The Commission has issued the enclosed Amendment No. 76 to Facility License No. DPR-33 for the Browns Ferry Nuclear Plant, Unit No. 1. This amendment changes the Technical Specifications in response to your request of April 29, 1981 (TVA BFPN TS 161), as supplemented by your letters of June 12, 1981 and July 13, 1981. The changes to the Technical Specifications (1) incorporate the limiting conditions for operation of the facility in the fifth fuel cycle following the current refueling outage, (2) reflect new primary containment atmospheric monitoring instrumentation installed during this outage, and (3) reflect modifications which we required to be made to the torus.

BROWNS FERRY NUCLEAR PLANT, UNIT NO. 1

Amendment No. 76
License No. DPR-33

ATTACHMENT TO LICENSE AMENDMENT NO. 76

Figure 3.5.K-1
MCPR LIMITS*

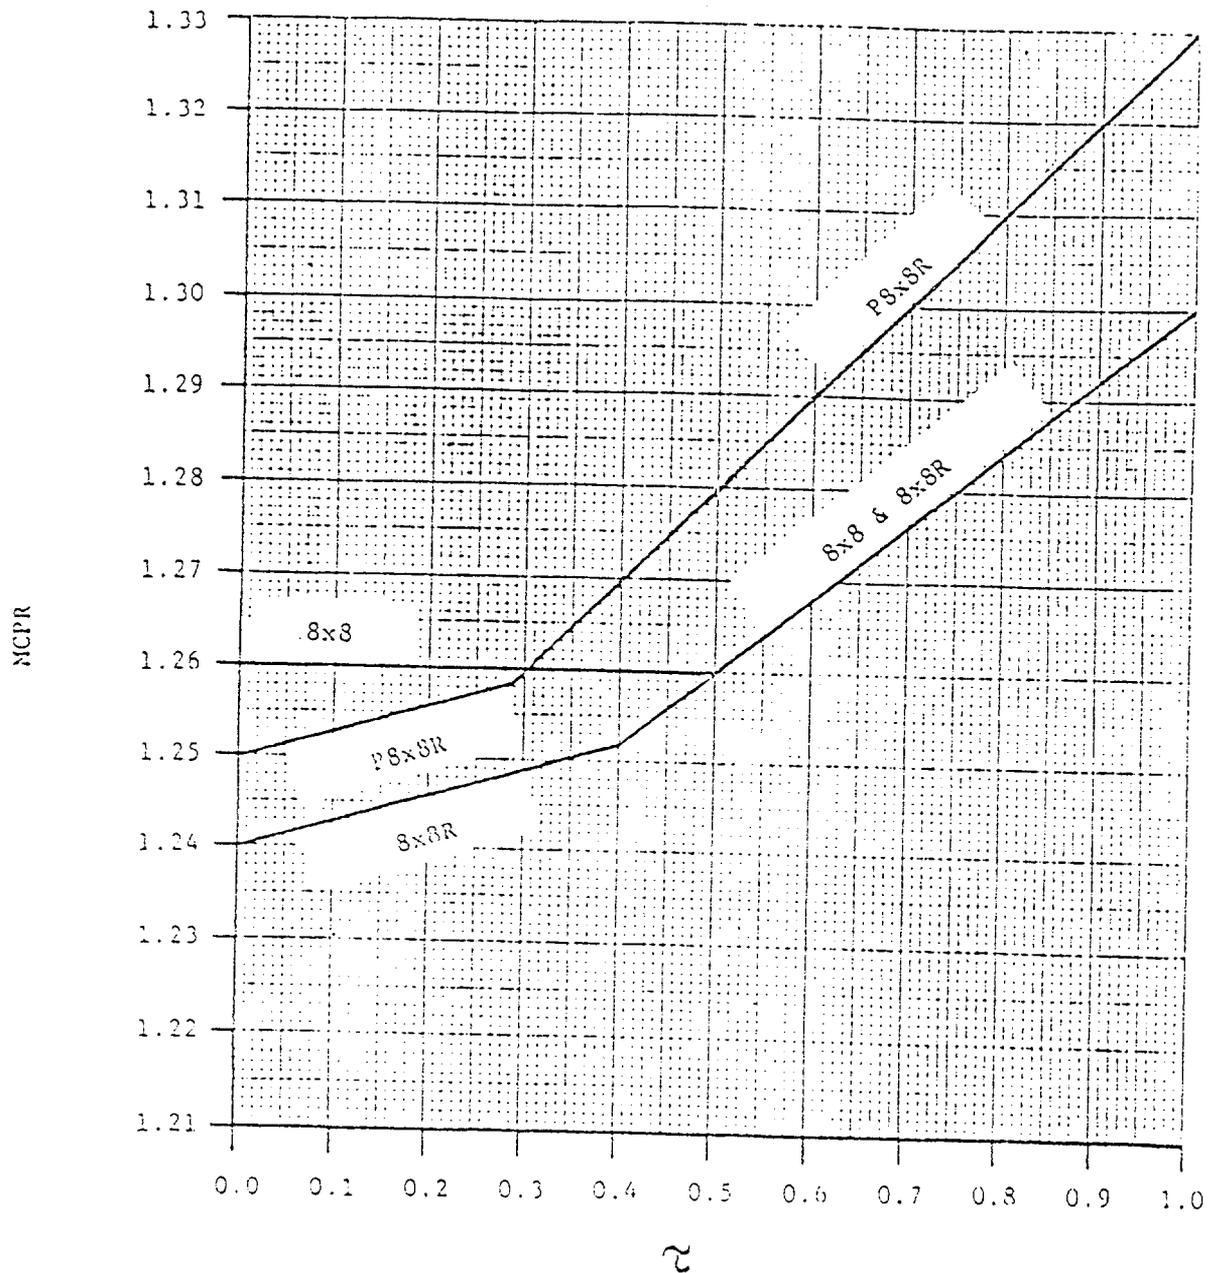
Pgs 160 and 172b - As supported by the reload submittal, the operating limit MCPR's are being changed. Since the MCPR's were determined by the OLYN Code (rather than the REDY Code), OLMCPR's are now calculated from two curves rather than being a single value (or a ramp change with fuel exposure).

The minimum critical power ratio (MCPR) as a function of scram time and core flow, shall be equal to or greater than shown in Figure 3.5.K-1 multiplied by the K_f shown in Figure 3.5.2, where:
